Structural Assessment
Garberville Veterans Building
Garberville, CA

KPFF Consulting Engineers
San Francisco, CA
February 26, 2021

STRUCTURAL ASSESSMENT

CONCEPTUAL SKETCHES:
 FOUNDATION PLAN
 KPFF

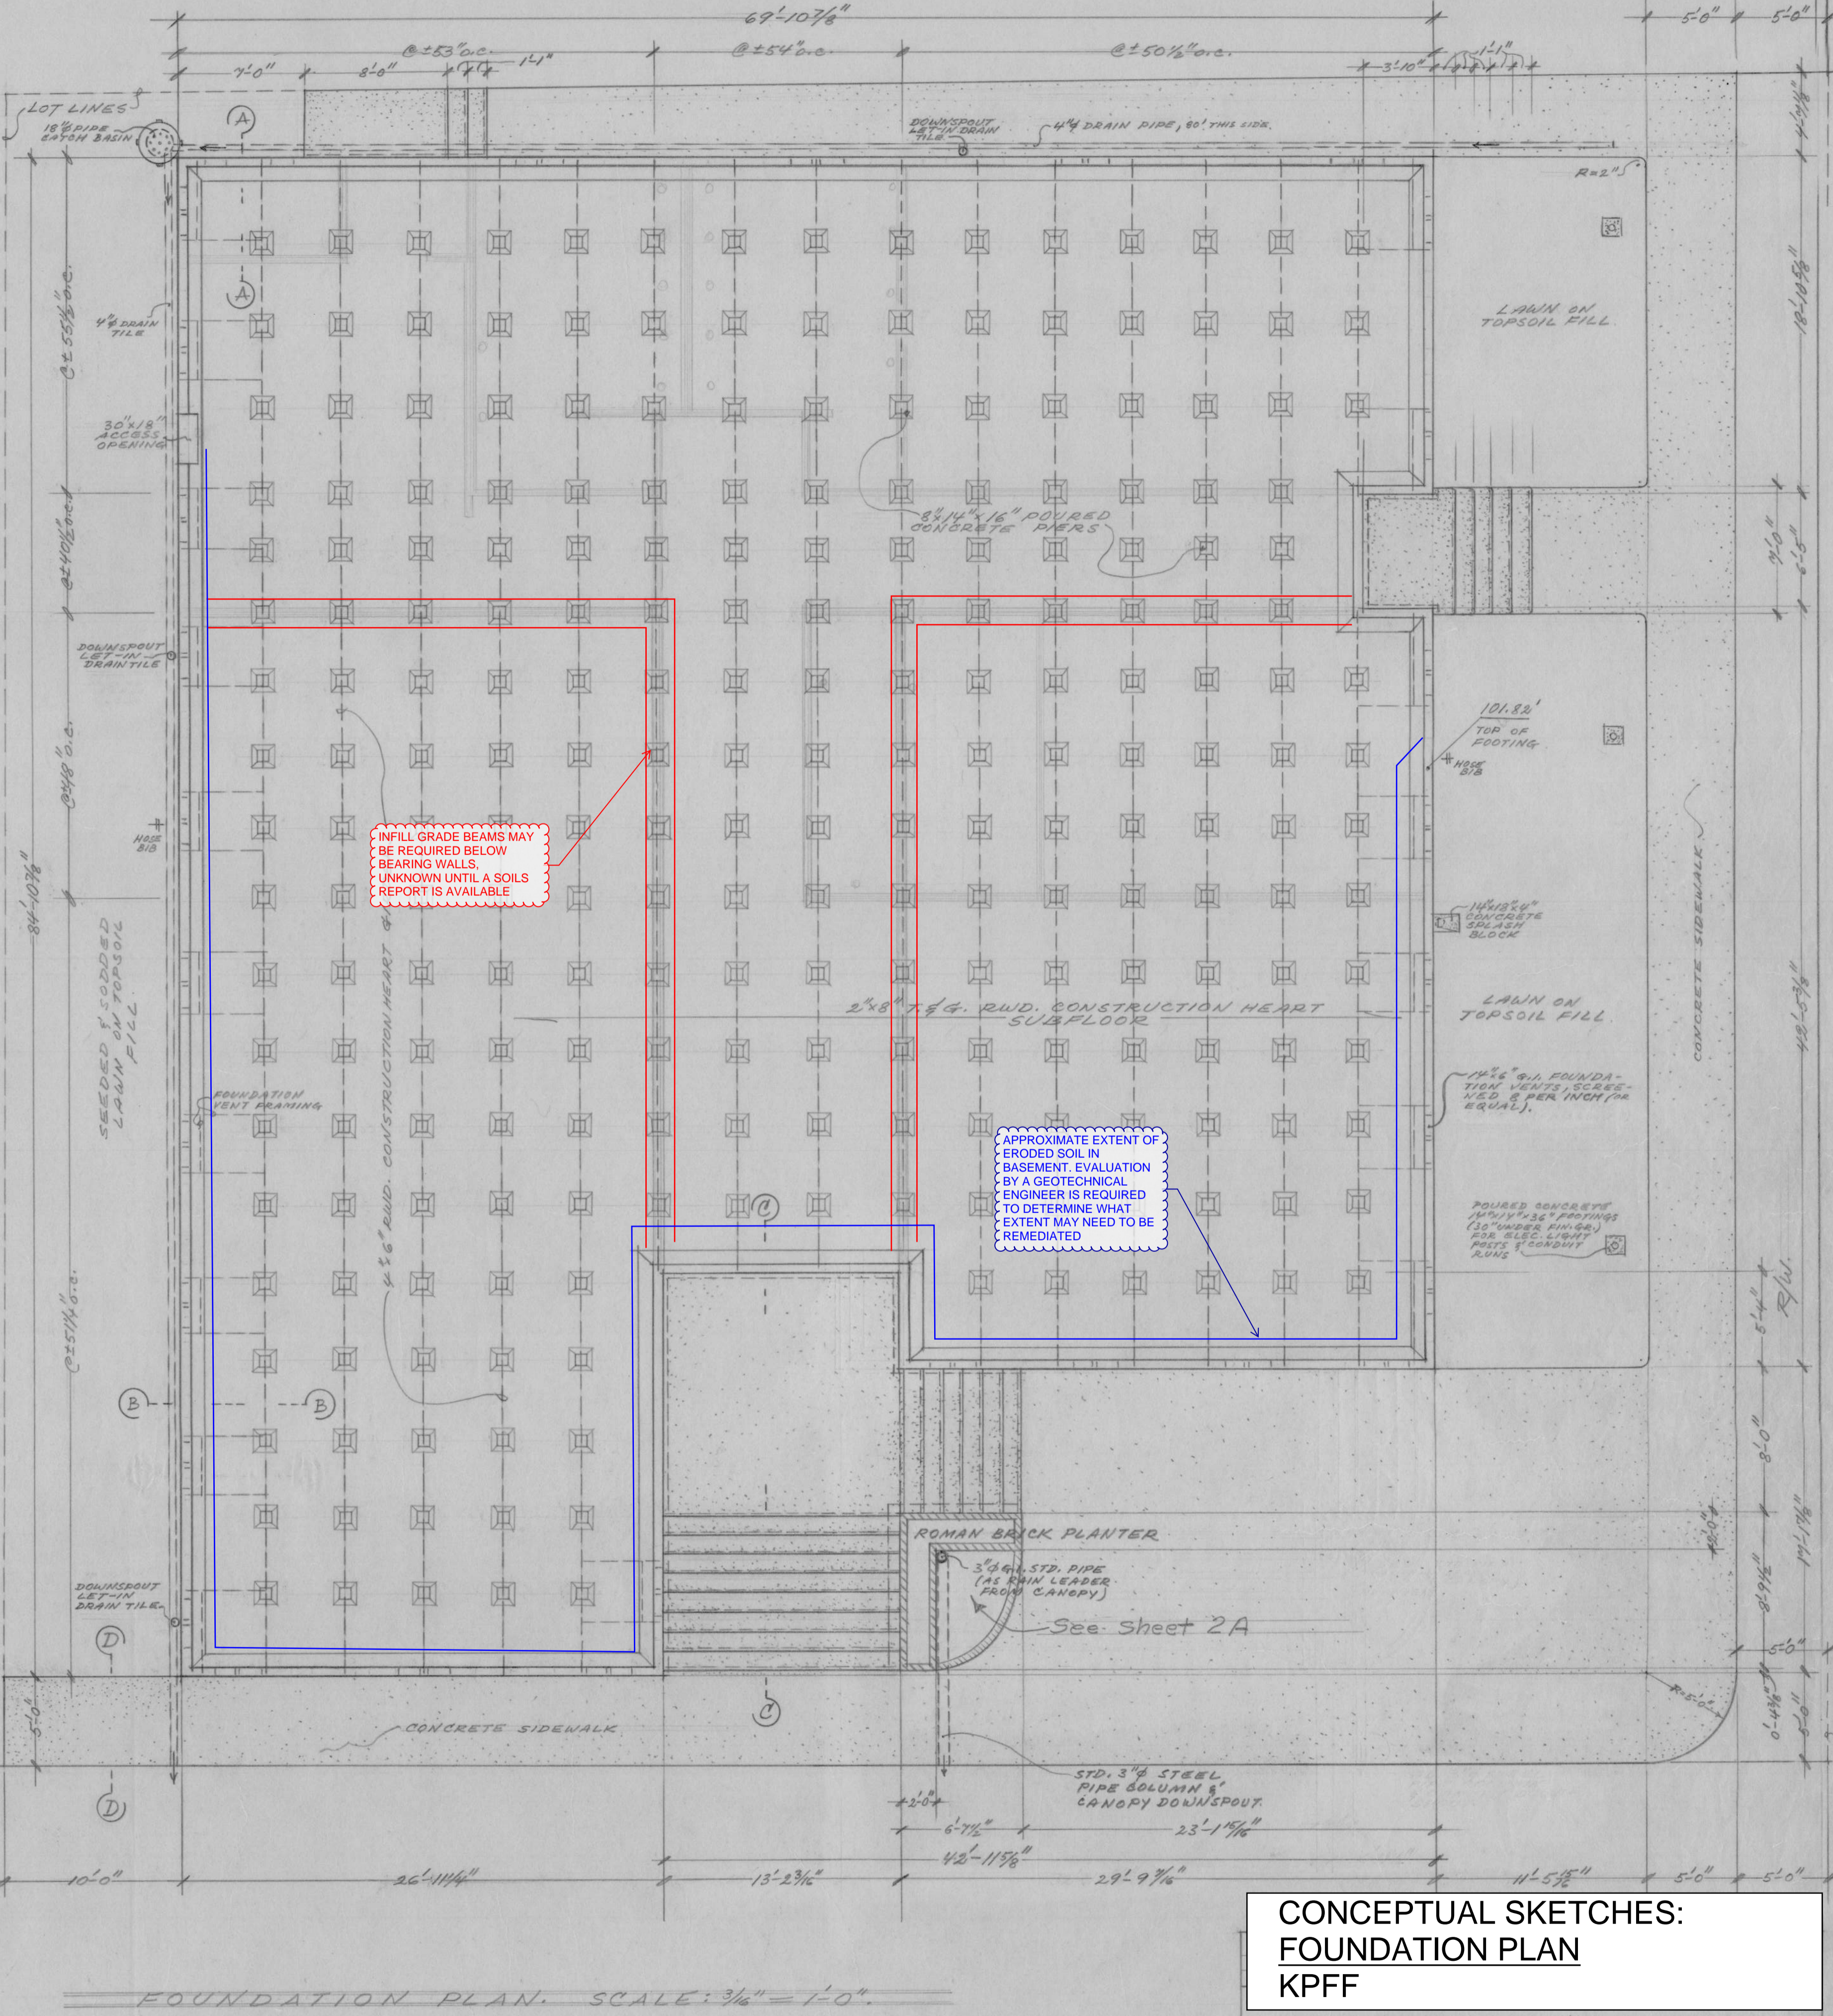
INFILL GRADE BEAMS MAY BE REQUIRED BELOW BEARING WALLS. UNKNOWN UNTIL A SOILS REPORT IS AVAILABLE.

APPROXIMATE EXTENT OF ERODED SOIL IN BASEMENT EVALUATION BY A GEOTECHNICAL ENGINEER IS REQUIRED TO DETERMINE WHAT EXTENT MAY NEED TO BE REMEDIATED.

CONCEPTUAL SKETCHES: FLOOR PLAN KPFF

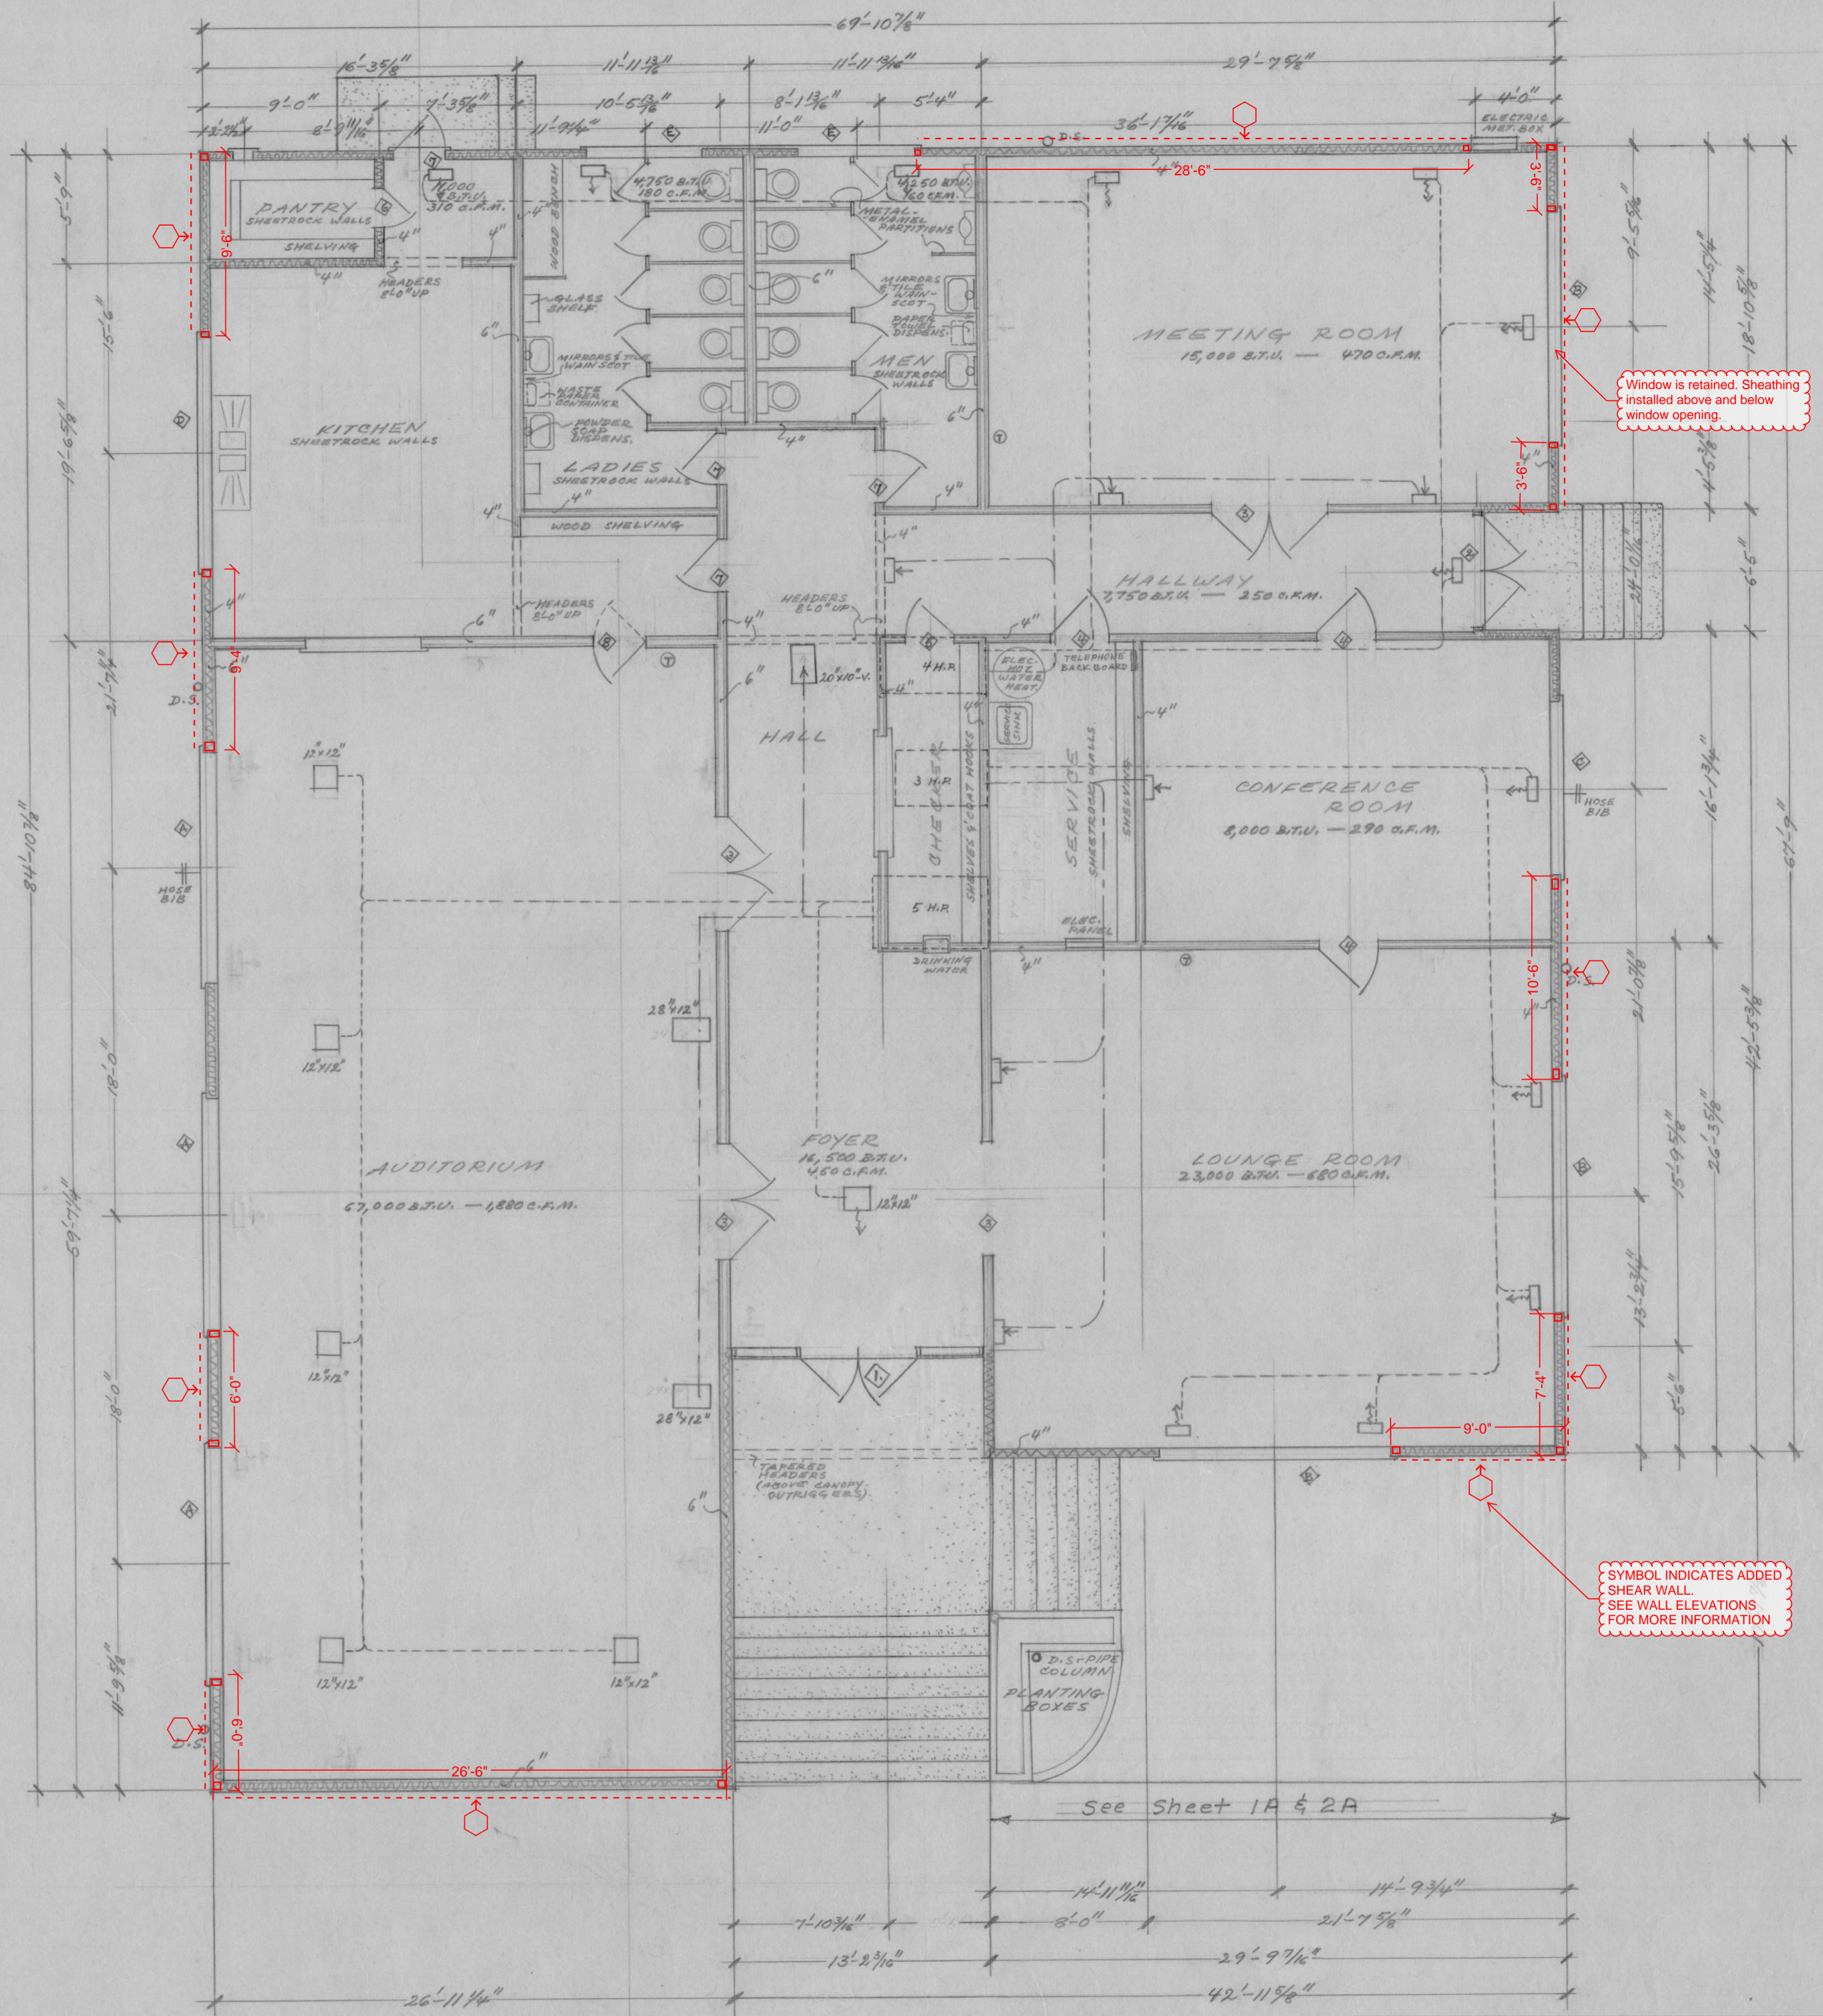
Window is retained. Sheathing installed above and below window opening.

SYMBOL INDICATES ADDED SHEAR WALL. SEE WALL ELEVATIONS FOR MORE INFORMATION.
